# 2014 - 2020 Corvette: Service Bulletin: #17-NA-040: Brake Squeal or Squeak Noise Intermittently on Initial Brake Applies - (August 11, 2020)

Subject:	Brake Squeal or Squeak Noise Intermittently on
	Initial Brake Applies

This Bulletin replaces PI1496C and PI0917F. Please discard PI1496C and PI0917F.

### **Buick Regal**

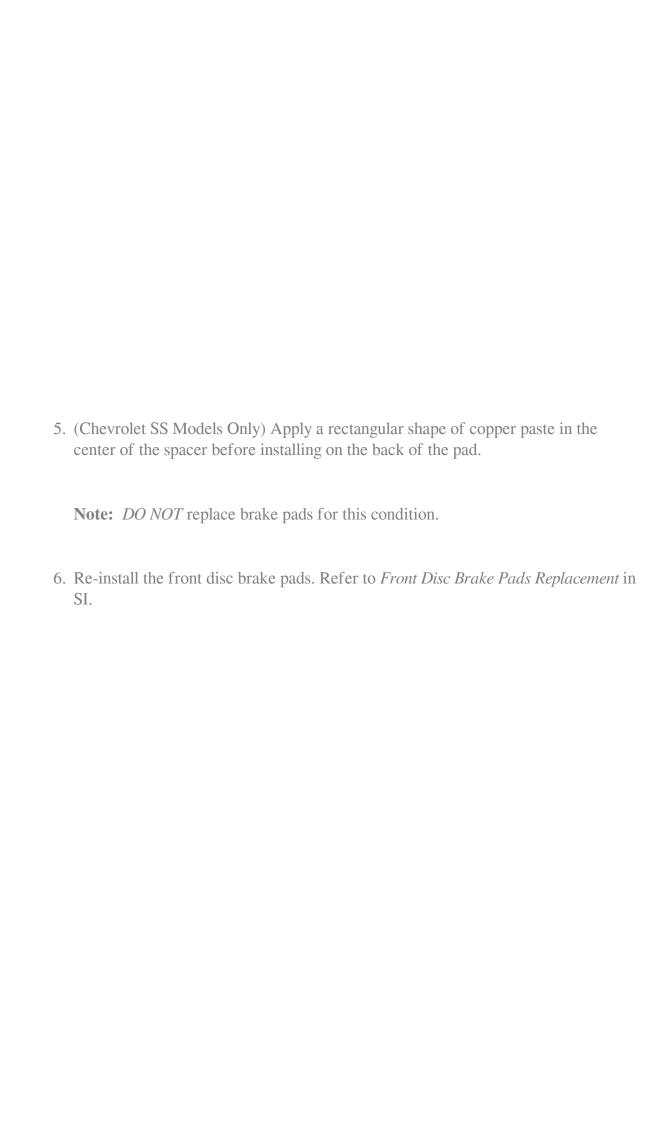
(1)	Abutment Area
-----	---------------

(1)	Cleaned Abutment Area
(2)	Correct Amount of Copper Paste
(3)	Incorrect Amount of Copper Paste

**Note:** Avoid a light apply of the paste as illustrated above.

- 1. Remove the front disc brake pads. Refer to *Front Disc Brake Pads Replacement* in SI.
- 2. Using acrysol Kent Industries Part# P2005 or equivalent, wipe clean both ends of the abutment area on the front pads and calipers.
- 3. Apply approximately 0.10 g (0.0035 oz) of copper paste to each end of the disc brake pad abutments that contact the brake caliper bracket.
